# UNITED STATES PATENT AND TRADEMARK OFFICE

APPLICATION NO.	FILING DATE	FIRST NAMED INVENTOR	ATTORNEY DOCKET NO.	CONFIRMATION NO.
10/760,409	01/21/2004	Gerard D. Agnew	84732/2900 TAL	1209
20736 7590 10/16/2007 MANELLI DENISON & SELTER 2000 M STREET NW SUITE 700 WASHINGTON, DC 20036-3307			EXAMINER MERCADO, JULIAN A	
			ART UNIT 1795	PAPER NUMBER
			MAIL DATE 10/16/2007	DELIVERY MODE PAPER

## Office Action Summary

## DETAILED ACTION

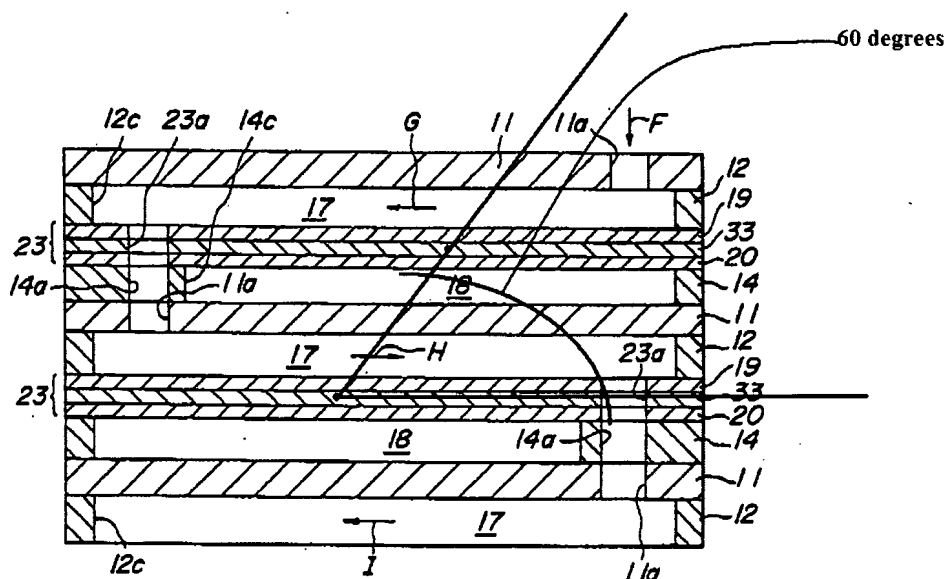
For claims 1, 27, 28, 49, Ishida teaches a solid oxide fuel cell stack comprising a plurality of solid oxide fuel cell modules [23], each module comprising an elongate hollow member [17] having flat surfaces and a passage extending longitudinally therethrough for the flow of a reactant, the surfaces of adjacent modules being arranged substantially parallel and spaced apart, wherein the end of a module is connected to adjacent module to allow reactant to flow sequentially through the modules. See Figure 6 and col. 6 line 25 et seq. The modules are connected via connector [14a]. (ib.)

For claim 29, the hollow member has a plurality of passages [11a] and [23a]. (ib.)

For claim 42, and to the extent that this claim is understood by the examiner notwithstanding the 35 U.S.C. 112, second paragraph rejection (discussion above), the modules [23] in Ishida share a common plane (such as the plane of the page) and are considered undulating insofar as having sequential 180° turns for the reactant stream. (shown by the arrows) This feature is also considered readable on claim 56.

For claim 44, and to the extent that this claim is understood by the examiner notwithstanding the 35 U.S.C. 112, second paragraph rejection (discussion above), in Ishida the center lines of the modules are estimated as approximately 60°.
